Architect's Supplemental Instructions

Architect's ASI No: 018

Project:
Webster University
Interdisciplinary Science
Building

Date Issued: 08/19/2016

FRAMING SECTIONS AND DETAILS

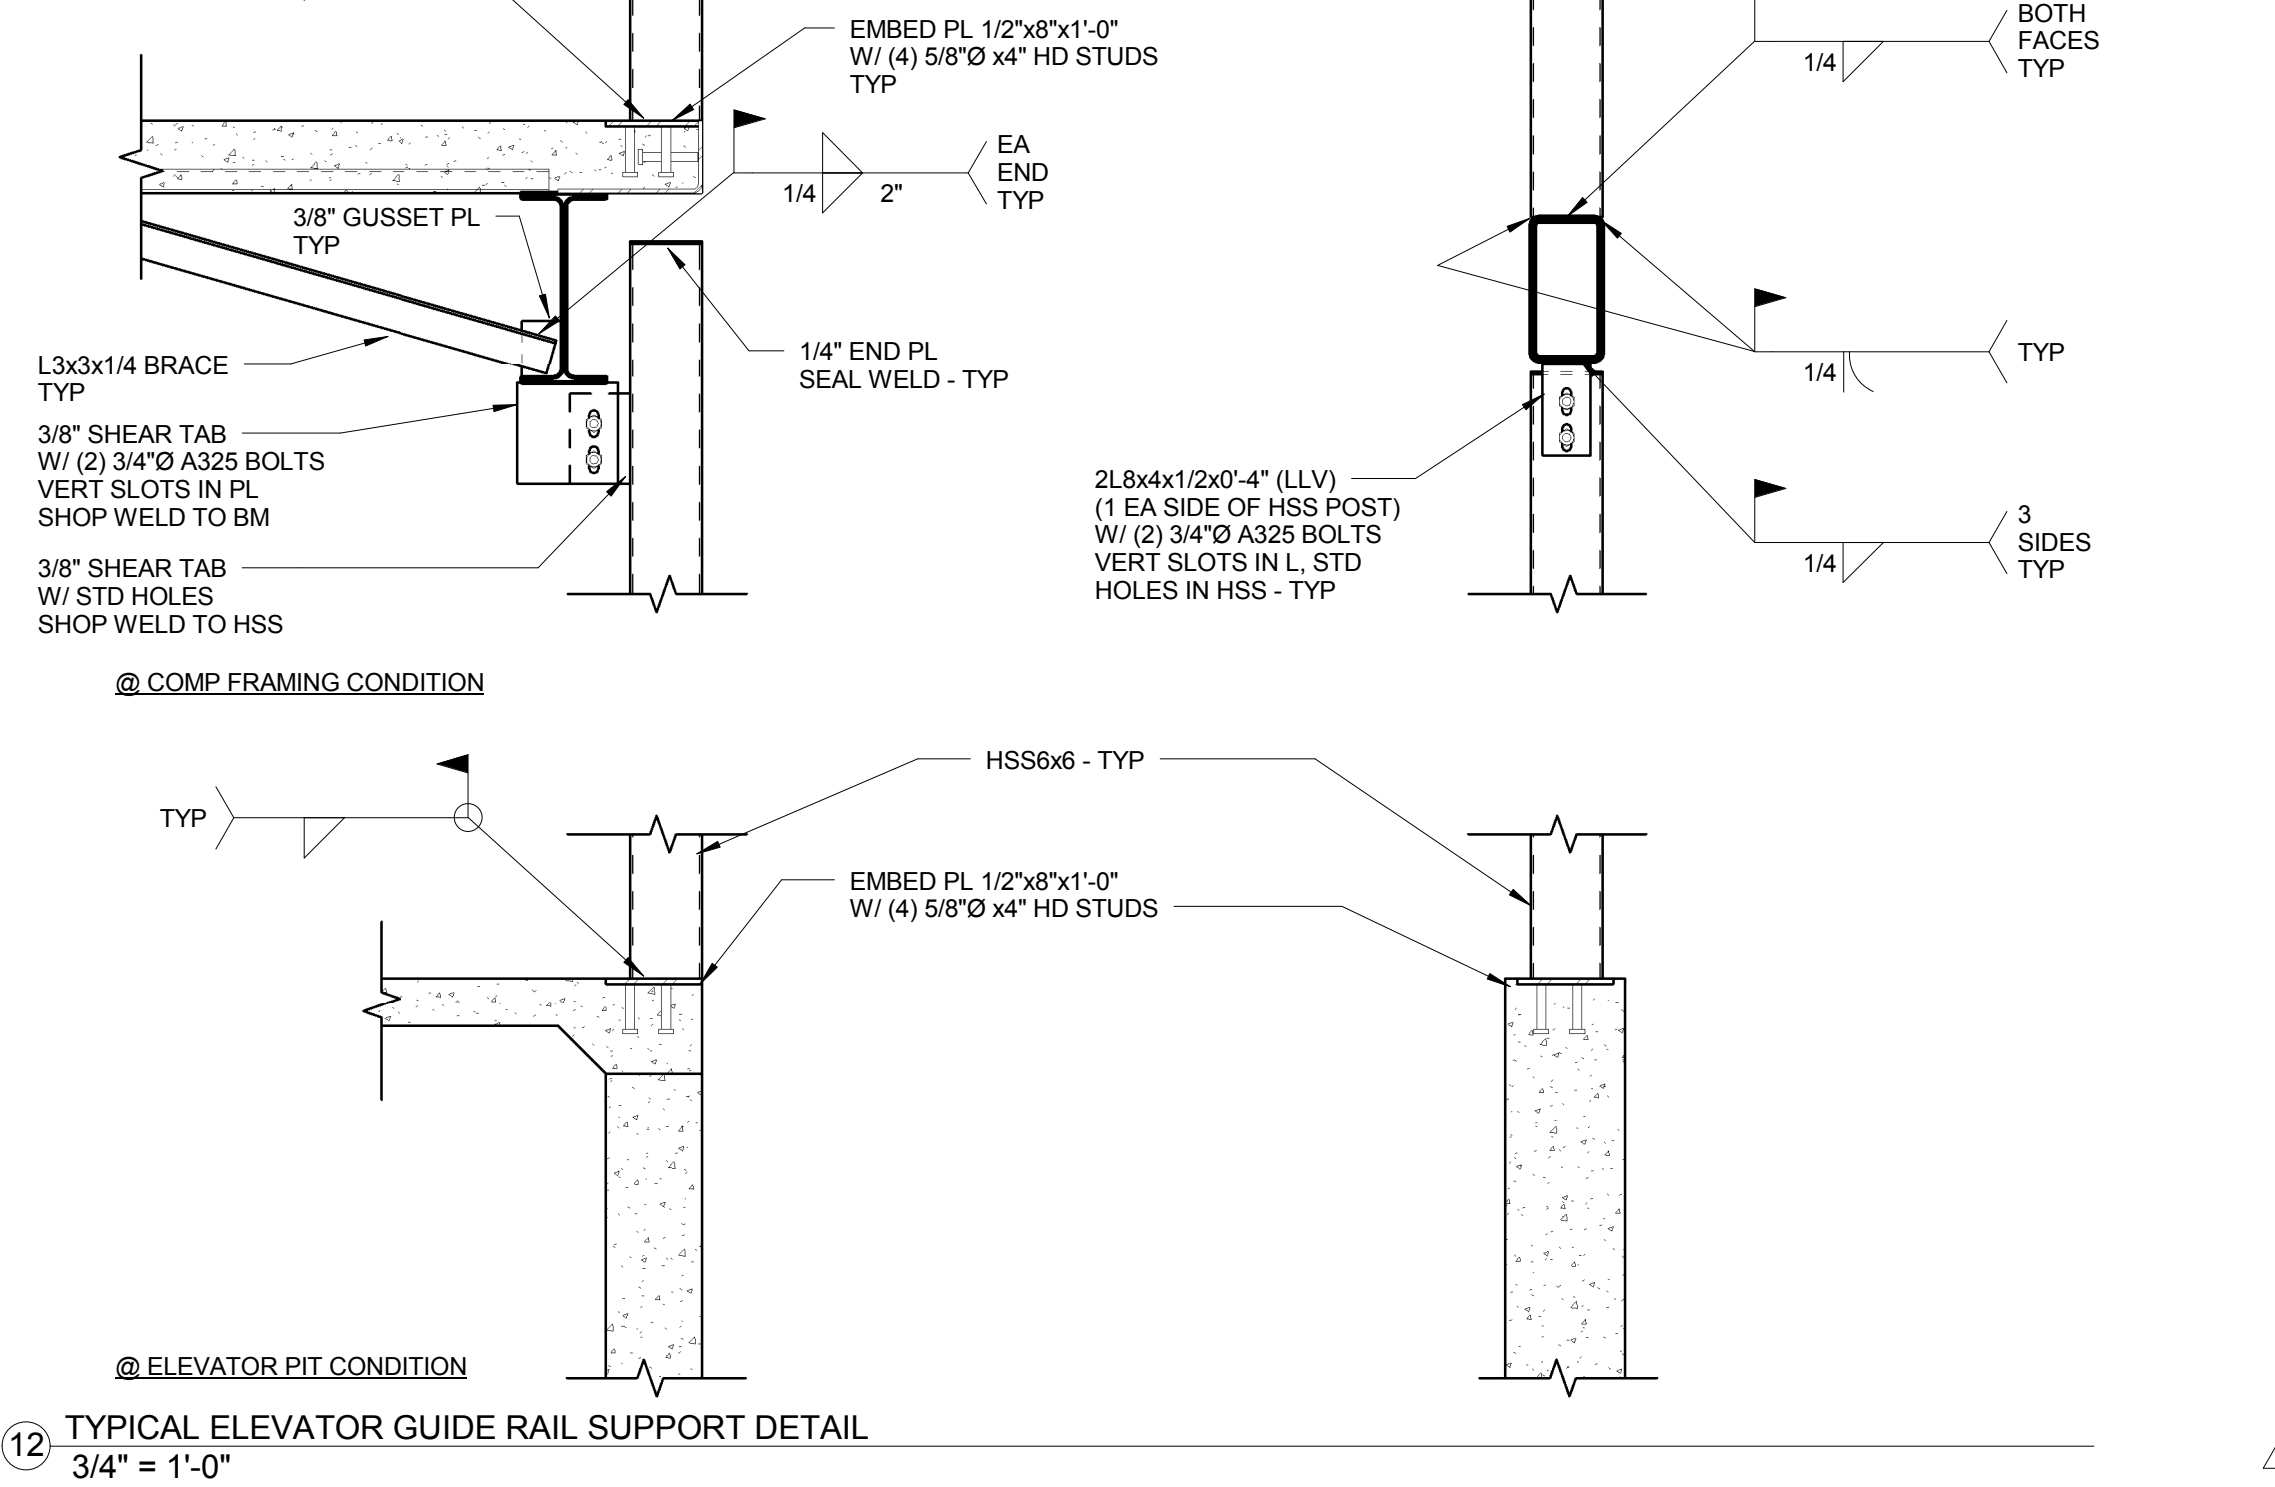
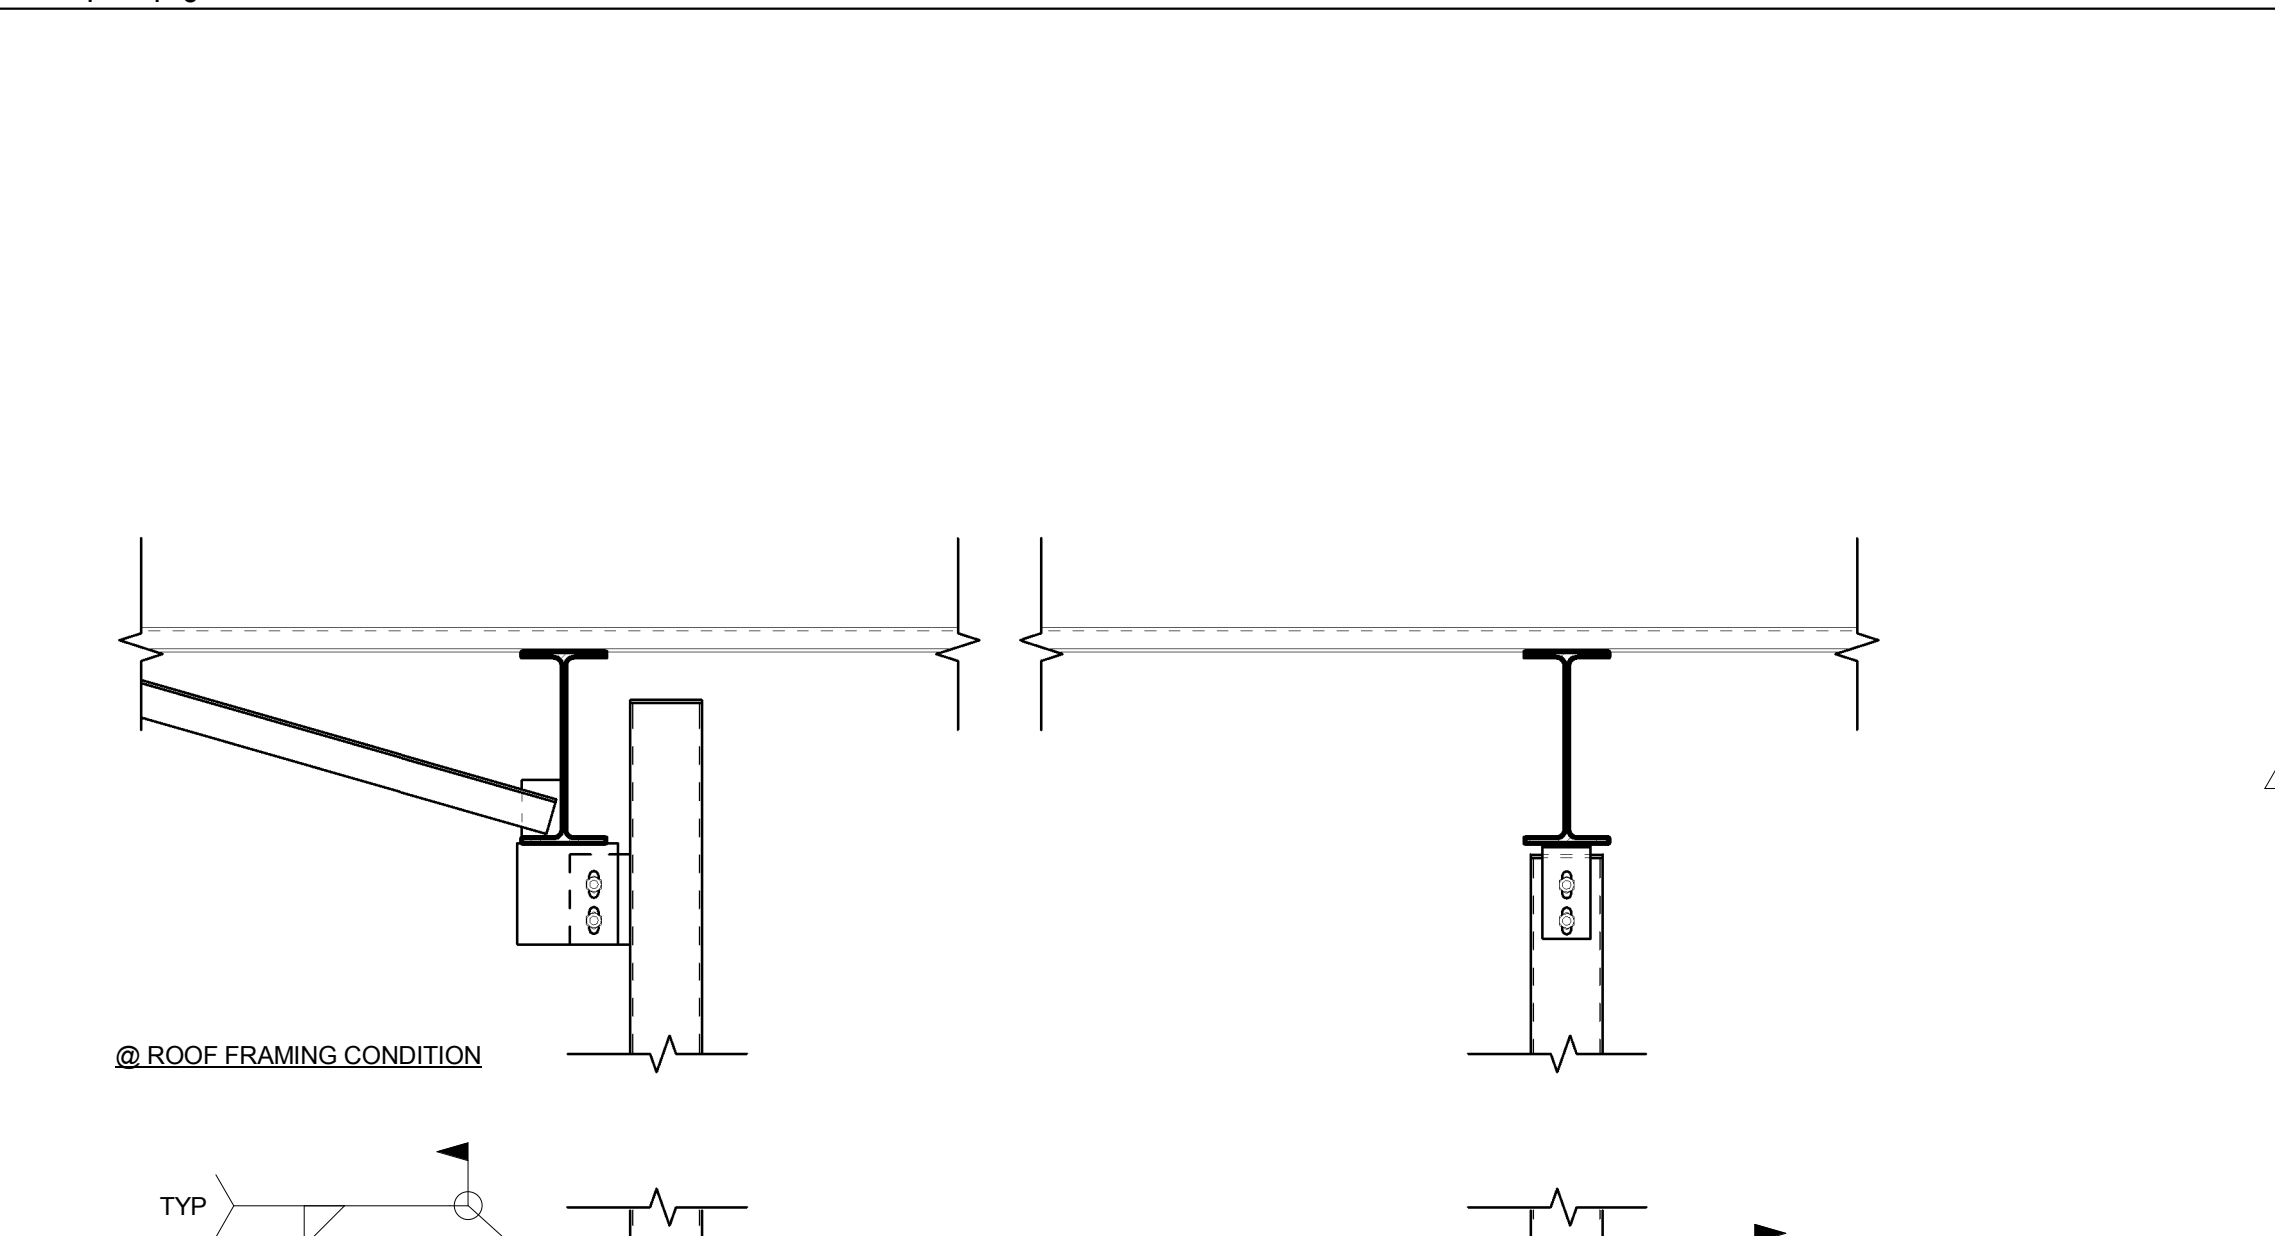
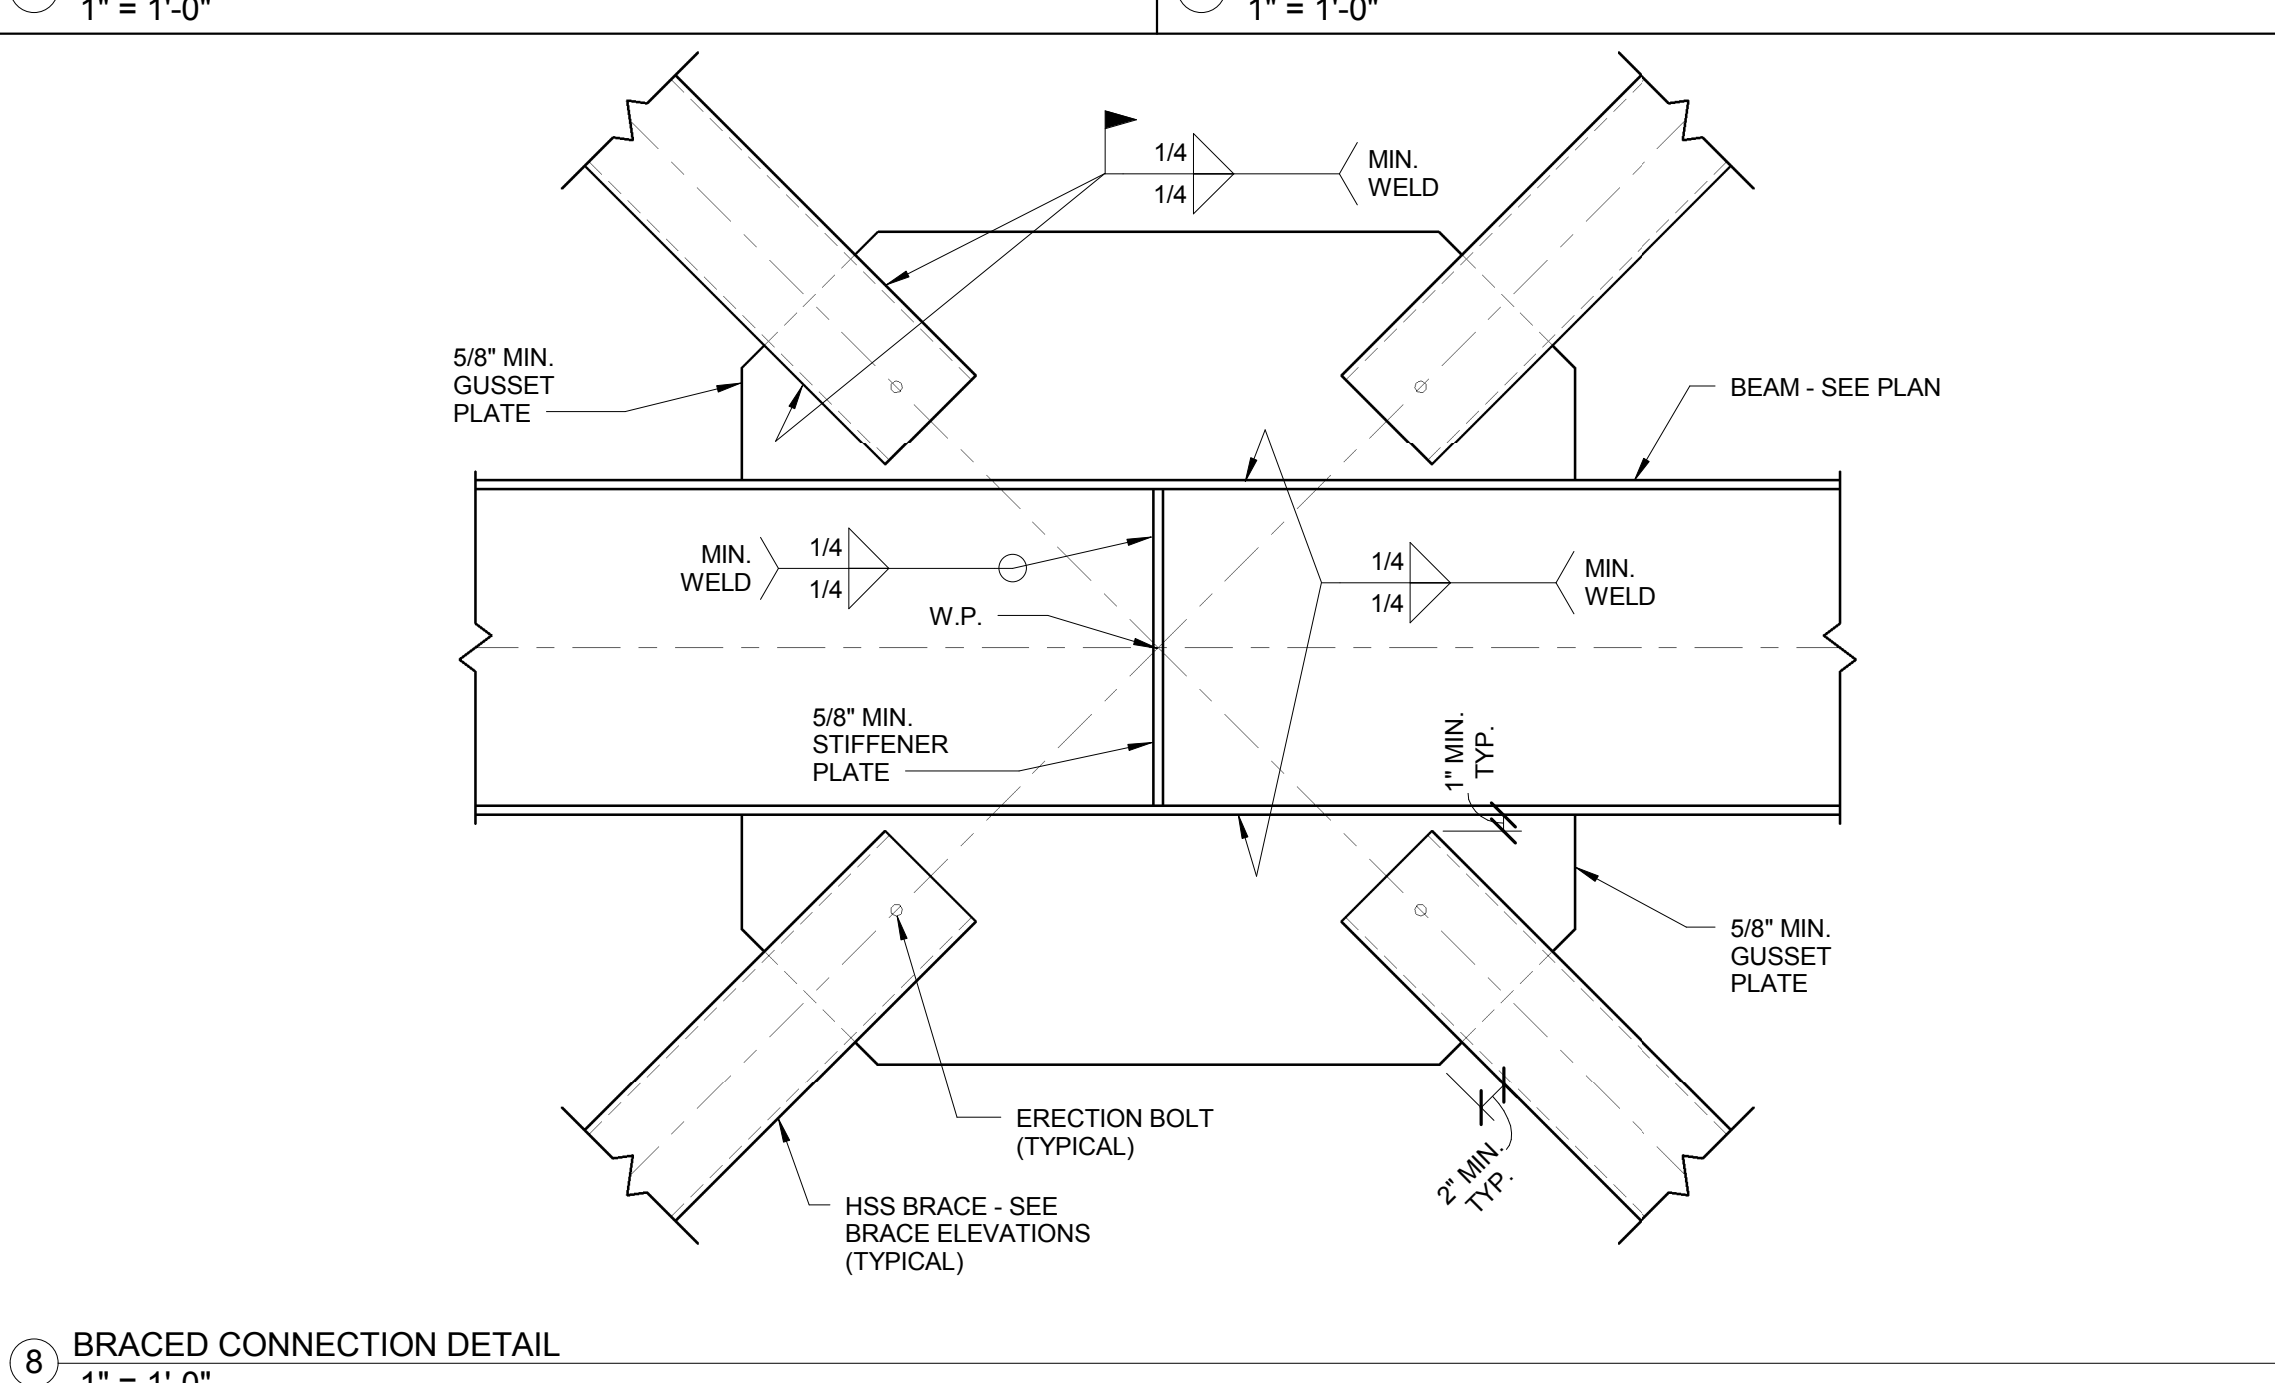
S0304:

Revisions to Detail number 16.
